<b>Topic</b>	Flying Spur HVAC Refrigeration Pipe Clip Replacement - Corrosion (SC14/02)
<b>Market area</b>	Russische Föderation (5RU), Russian Federation 935 Volkswagen Group RUS (6935), United Kingdom E01 Bentley UK (6E01), Germany E02 Bentley rest Europe (6E02), Japan E03 Bentley Japan (6E03), Australia E04 Bentley rest Asia and Australia (6E04), United States E05 Bentley USA and rest America (6E05), United Arab Emirates E06 Bentley Middle East and Africa (6E06)
<b>Brand</b>	Bentley
<b>Transaction No.</b>	2035328/2
<b>Campaign number</b>	EA02
<b>Note</b>	EA02
<b>Type</b>	Workshop Campaign
<b>US code</b>

### Technical background

Figure 1

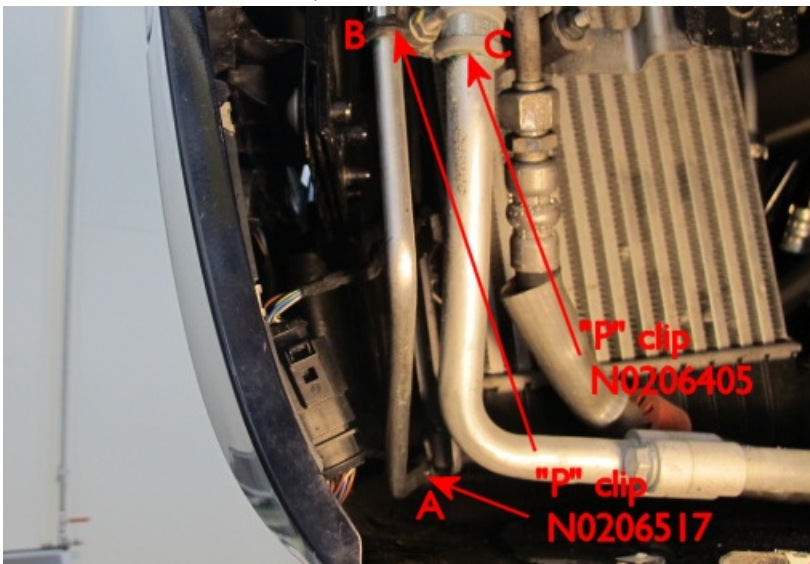
Extended durability trials have identified corrosion on the outside of the air conditioning pipe where it passed through the left hand front wheel arch area. This corrosion is only evident at the clipping point and is associated with the use of stainless steel clips. In extreme cases the corrosion would compromise the pipe integrity and result in refrigerant loss.

5. Referencing figure 1 identify the three P clips (A,B and C) located in the front left wheelarch that require replacement

- On cars where the pipe is serviceable, figure 3, fit three replacement clips. For position A and B fit new clip part number RSGUV1.10-15W1 in position C fit new clip part number RSGUV1.18-15W1. If either pipe is found to have extensive corrosion then both pipes should be replaced before replacing the clips, in this case follow the *Air conditioning pipe replacement* procedure detailed below.

Figure 2

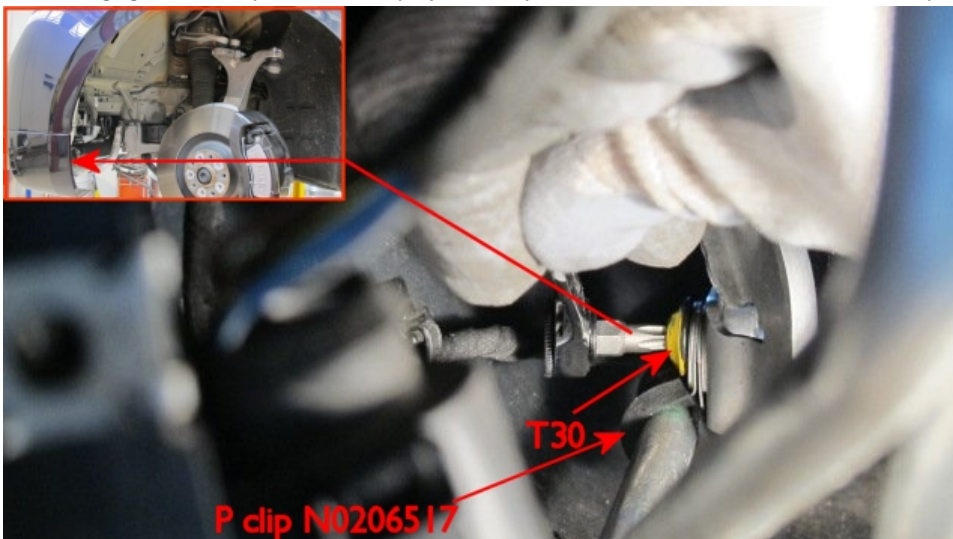
6. Using a T30 bit loaded into a ratchet spanner remove the fastener securing P clip (A). Remove and discard clip A (see Figure 1 and 2)

Figure 3

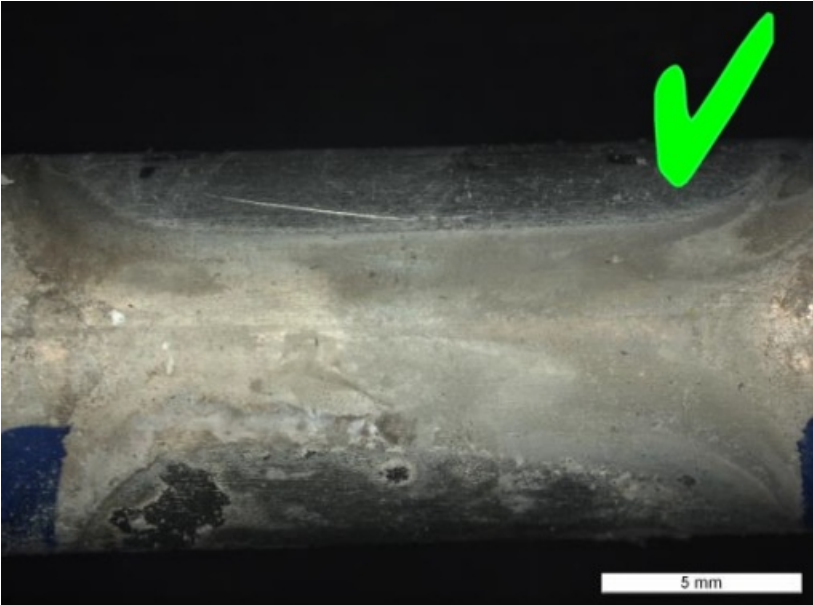
- The three locations from which the clips have been removed should now be inspected for surface corrosion, use of a mirror will aid inspection. Discolouration and light oxidation on the surface of the pipe is not detrimental and does not necessitate pipe replacement (see Figure 3). If the pipe surface shows signs of extensive corrosion and pitting (see Figure 4) then that pipe should be replaced

Figure 5

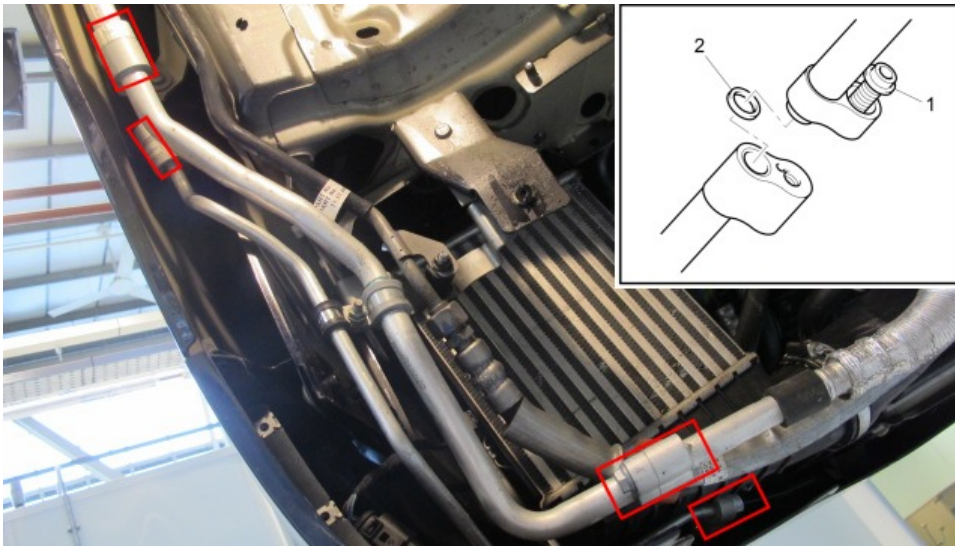
2. Locate the four joints securing the two pipes (see Figure 5). For each of the four joints remove the retaining screw -1- then separate the two pipes, discard the O ring -2-

3. Fit the two new pipes using new O rings coated in refrigerant oil. Tighten pipe joint retaining bolt -1- to 15Nm
  4. Fit and secure the pipes using the three new pipe clips
